RE: Water District 34 Water Measurement Matters.

EIM CANAL PRESEASON COMPLIANCE REPORT

RE: Compliance Report Notification

Eastside Compliance Report

Eastside Canal
Eastside @ Moore Diversion
30"

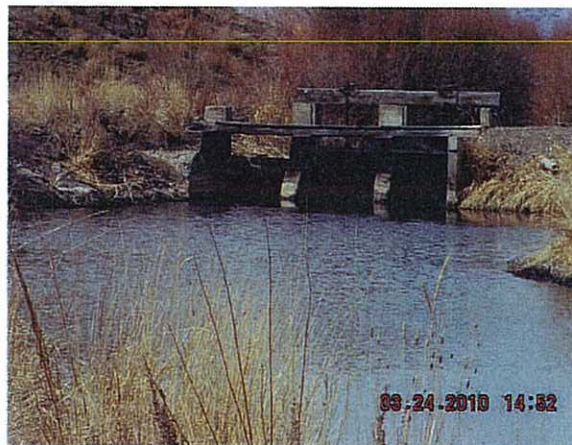
Broad Crest measuring device. Data logger will be installed at this canal heading.

Eastside Canal
Recharge Headgate
17"

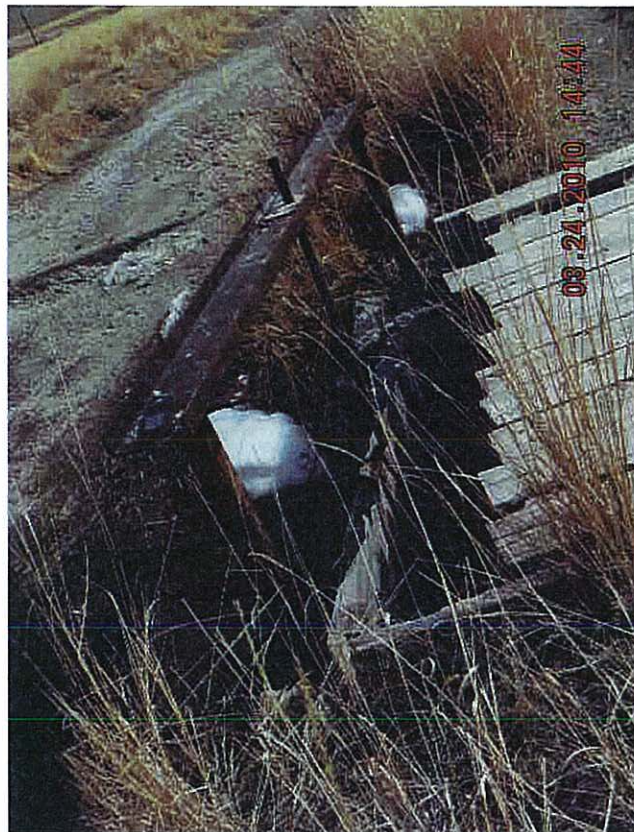
Active headgate. 4 ft. Parshall flume. Approach needs cleaning for accurate measurement. No wheel on gate stem (no control). Jim Rindfleisch and Ronald Sorensen had to hammer gate closed after a unauthorized diversion in 2007. Jim Rindfleisch put the wheel in his pickup.

Eastside Canal
King Mountain Ranch (lawn)
52"

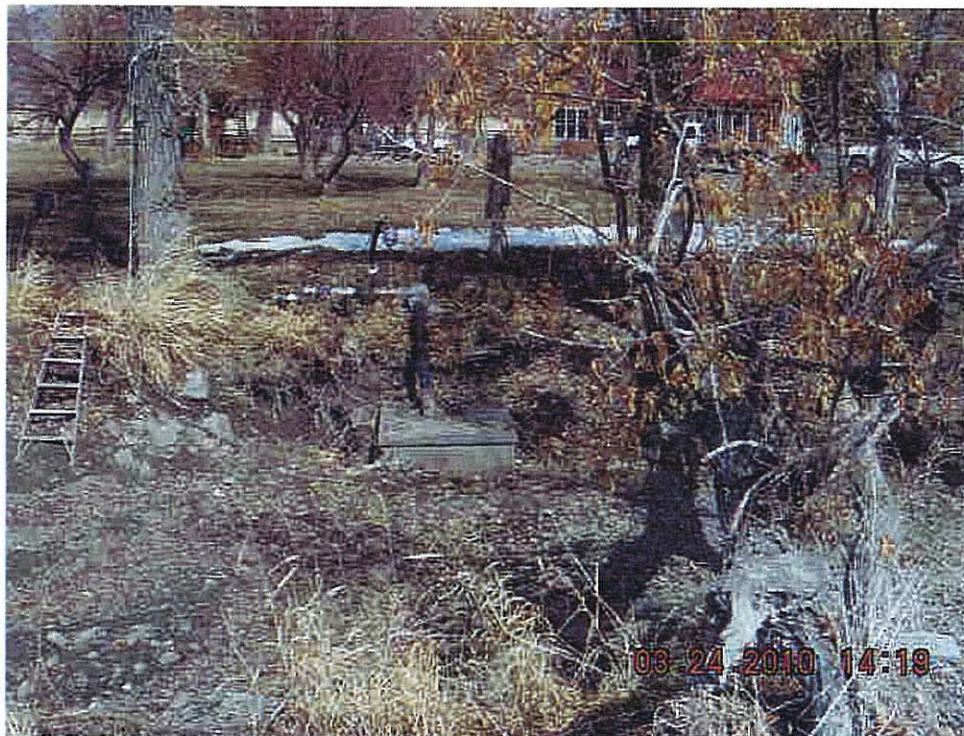
Unknown if this account is active or inactive. No measuring device.
Control is not adjustable and lockable.

Island Canal
Alvin Wheeler (South)
13"

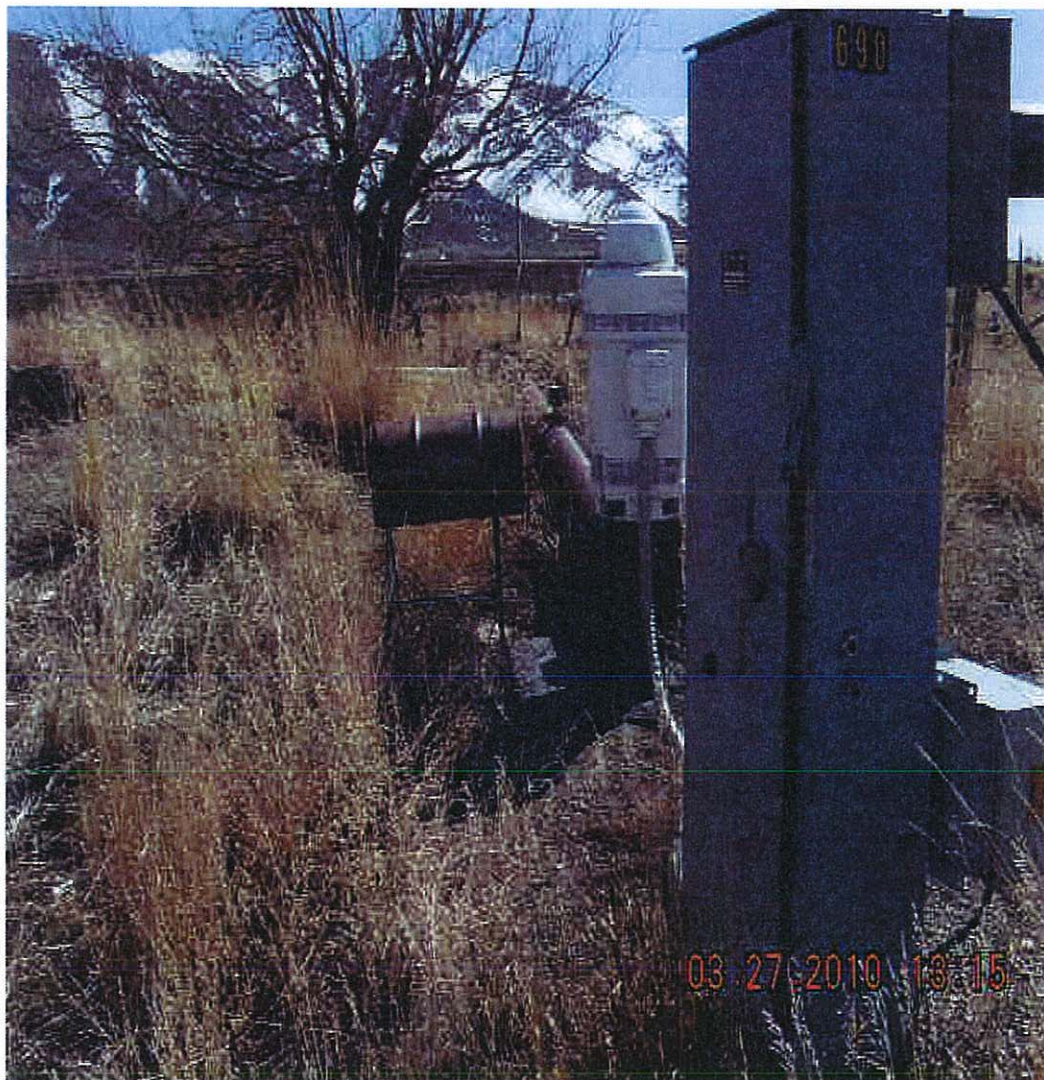
Active headgate. Adjustable and lockable control. 18 in. Parshall flume.
The sides of the flume are distorted by tree root over growth.

Tree roots in approach, roots have pushed sides in.

Island Canal
Isom # 1 Well
04"

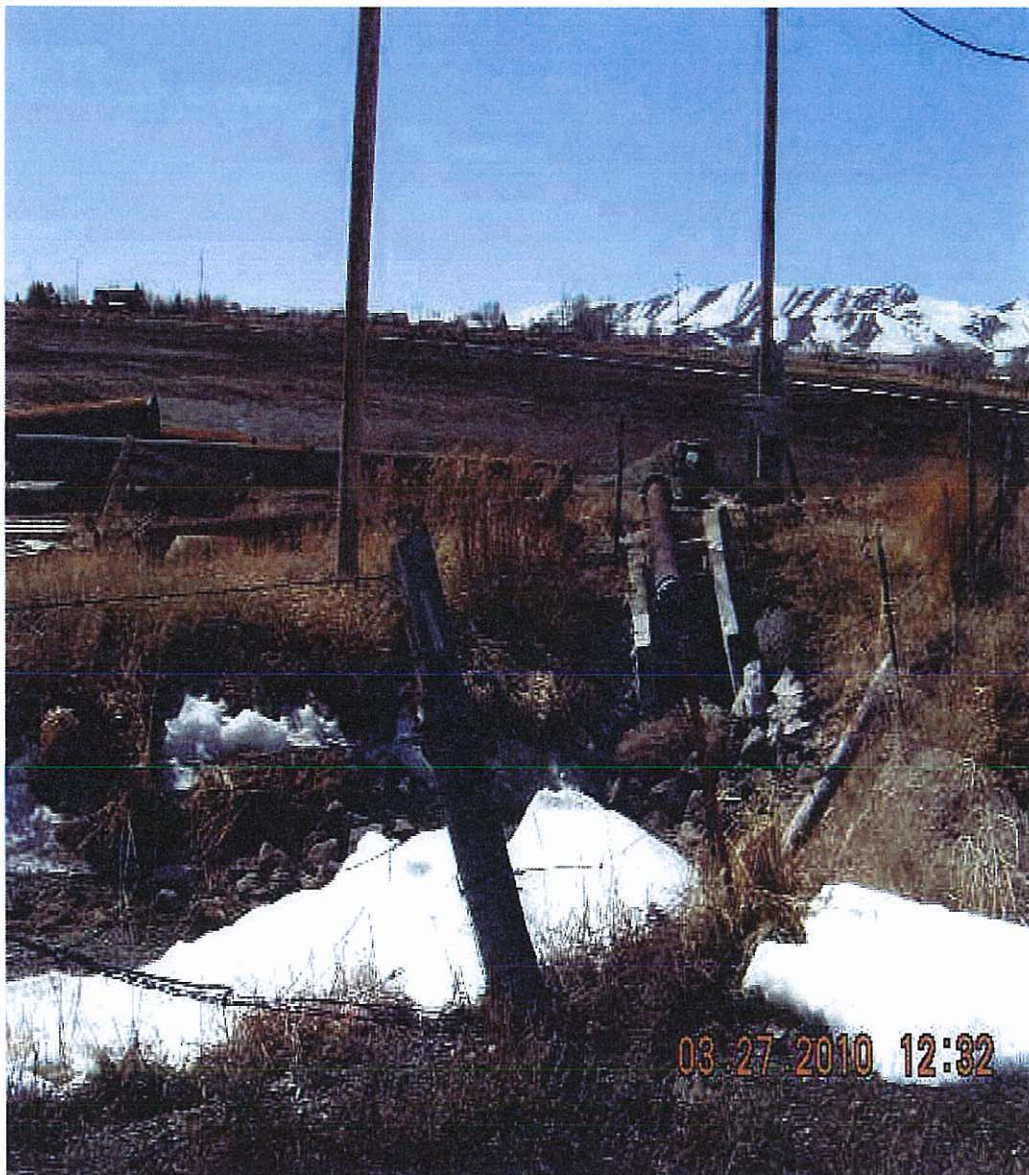
Active well. 3 ft. Cipolletti weir and stilling box.

Island Canal
Darrel McDonald Well
47"

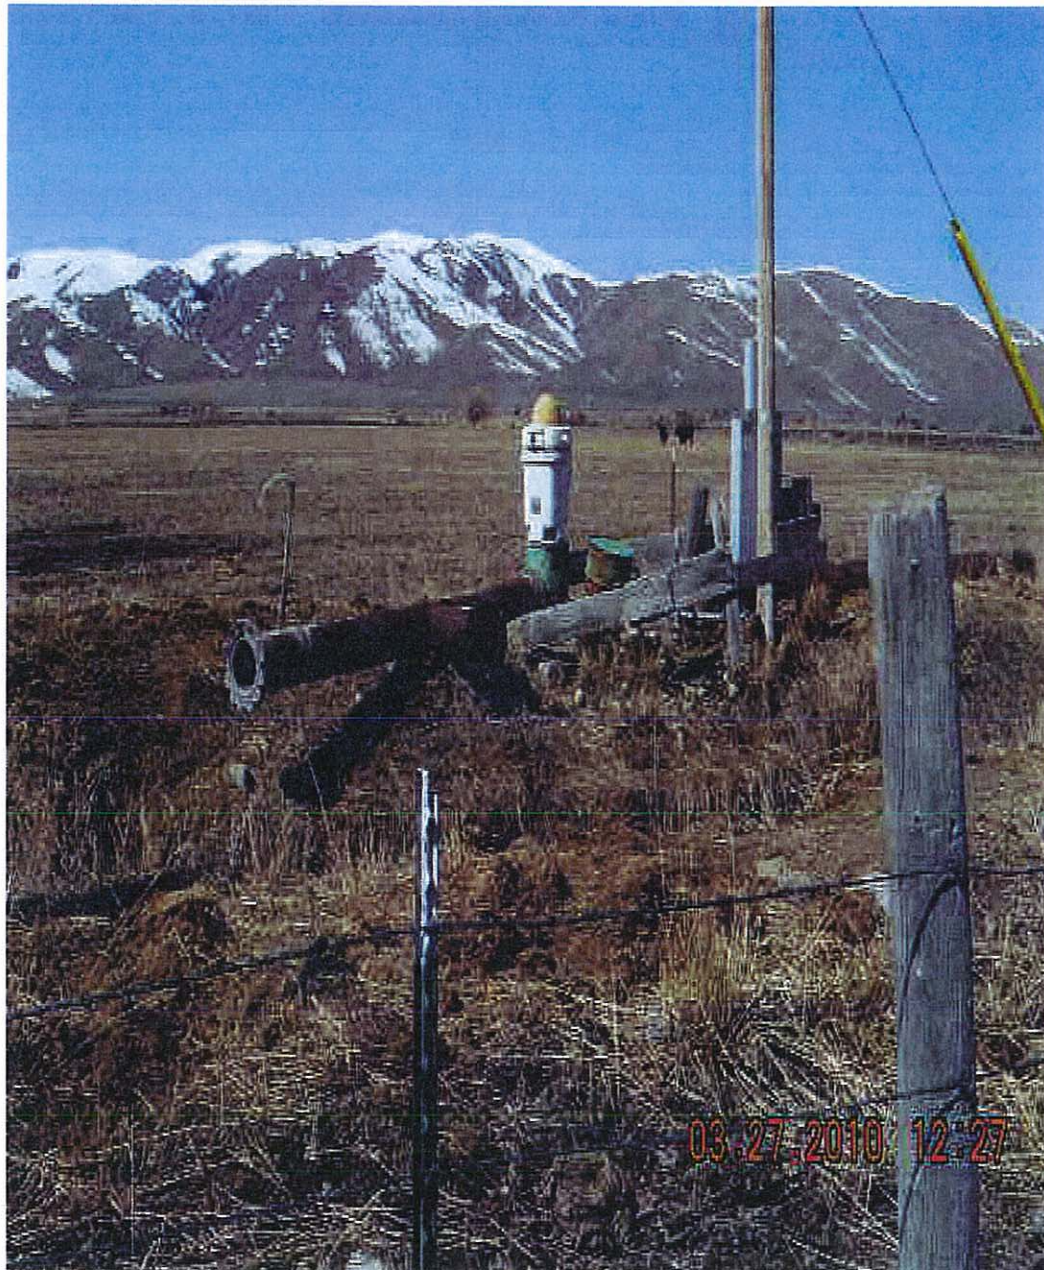
Active well. 10 in. restricted orifice. 12 in. discharge pipe.

Island Canal
Doug Hendricks
46"

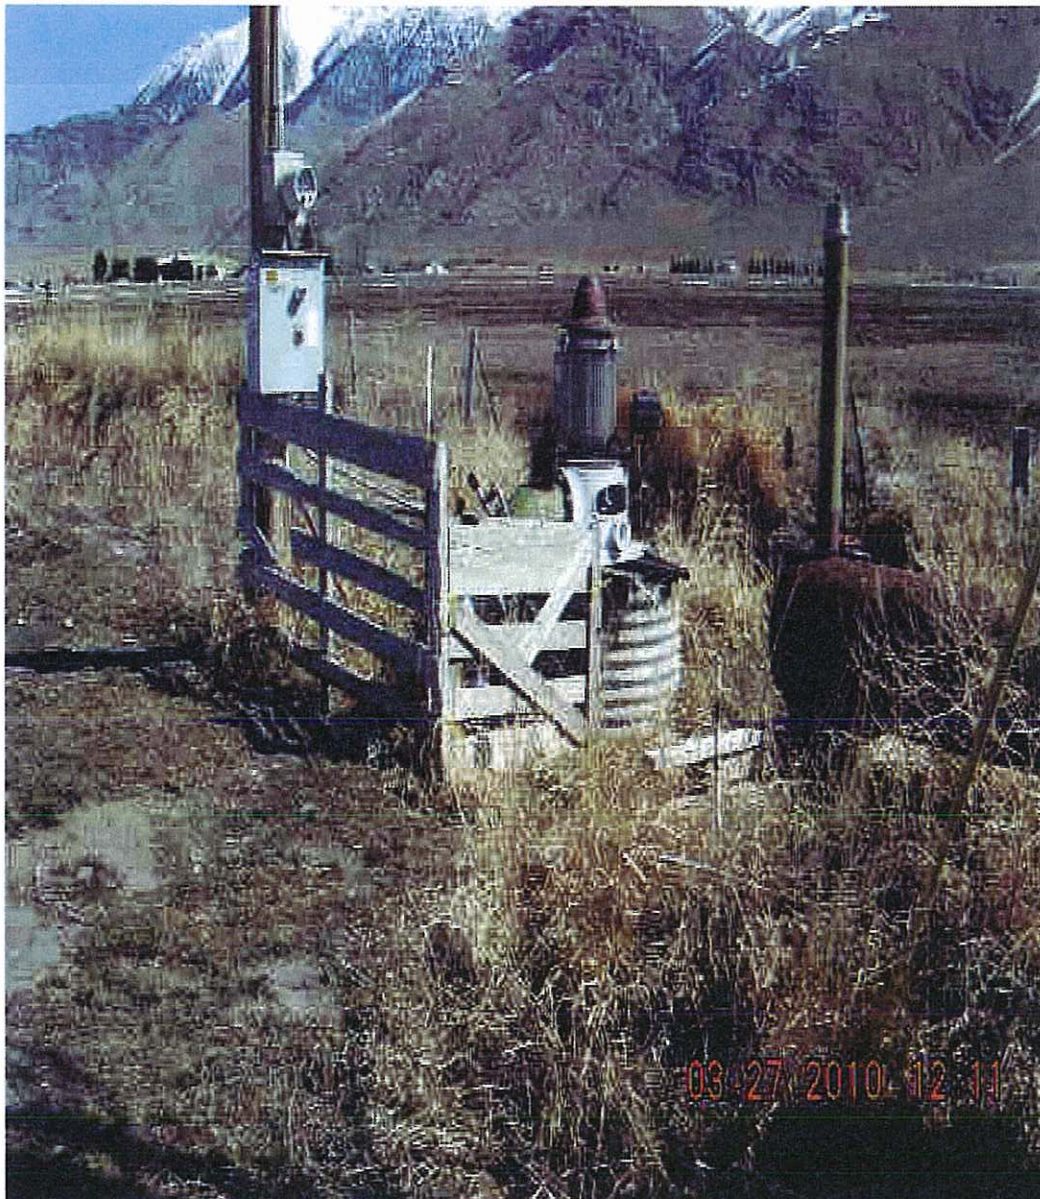
Active headgate. Adjustable and lockable control. No measuring device on pumping station. Measuring device is required for system to be in compliance.

Island Canal
Isom # 2 Well
47"

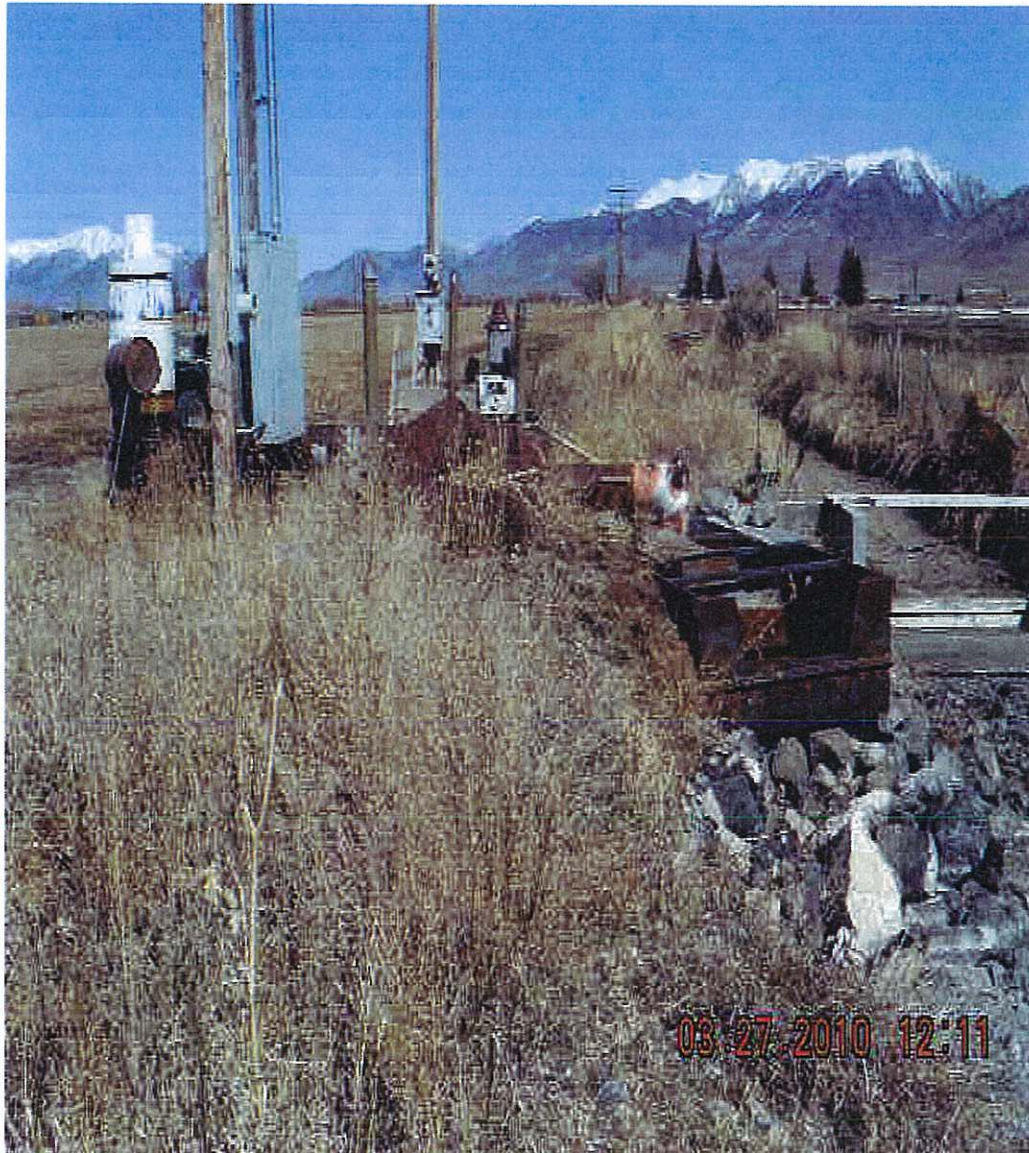
Active well. 3 ft. Cipolletti weir and stilling box.

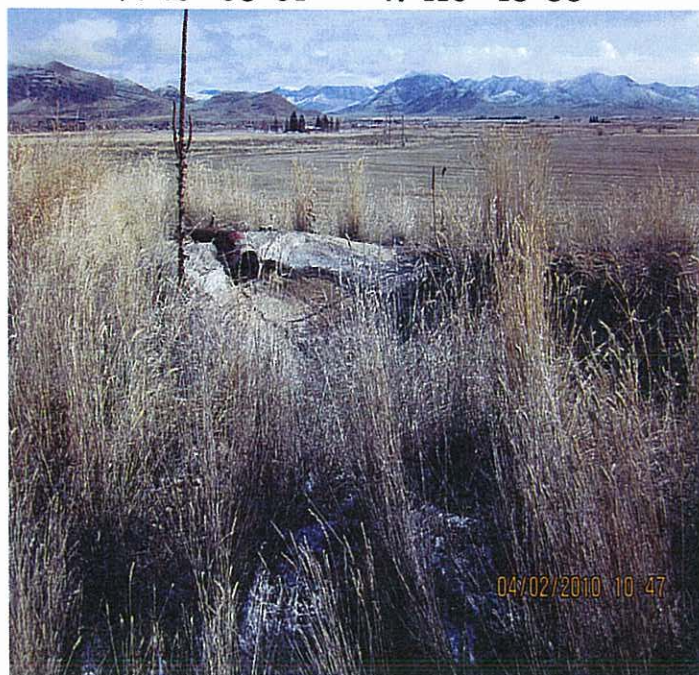
Adjustable and lockable control. No measuring device.

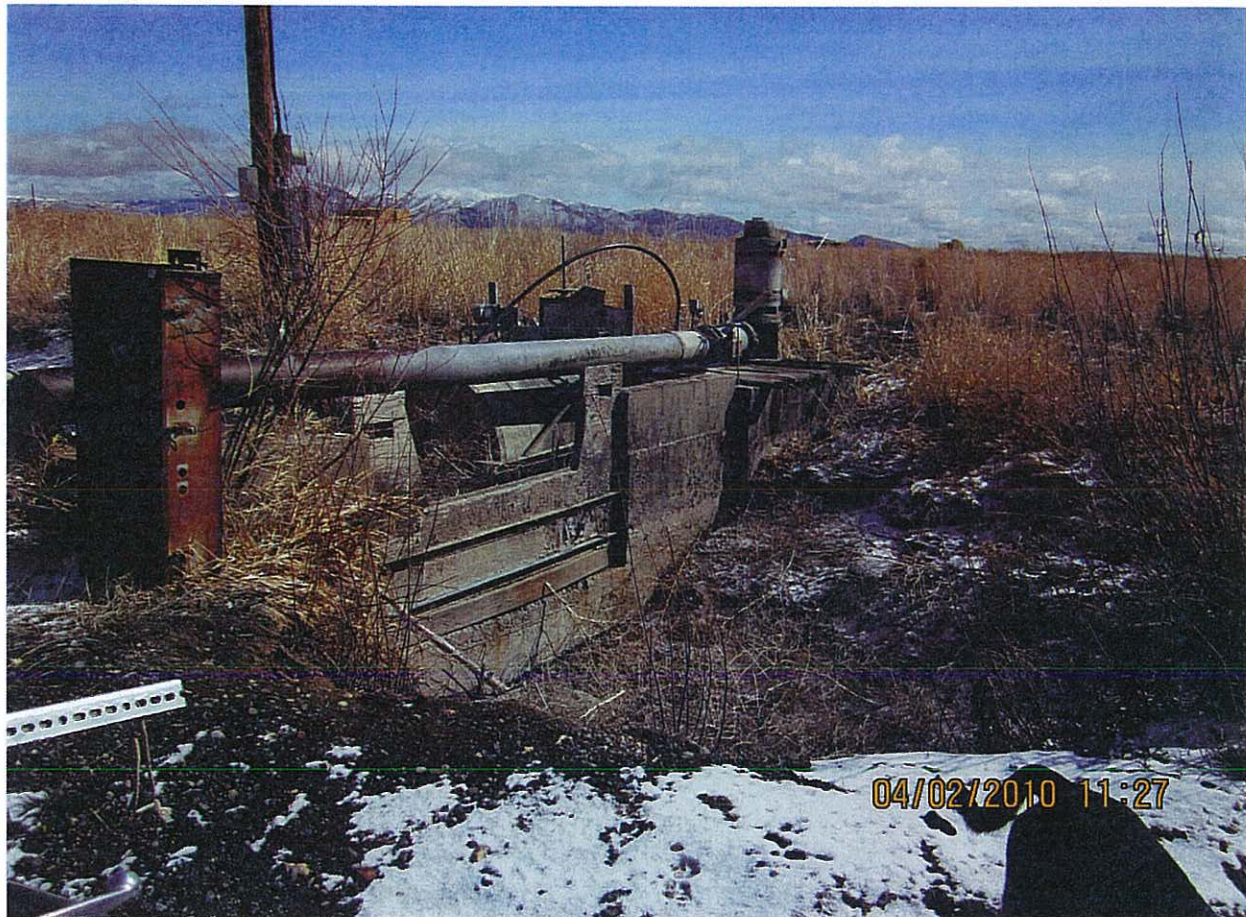
Inactive heading. Not lockable. No measuring device.
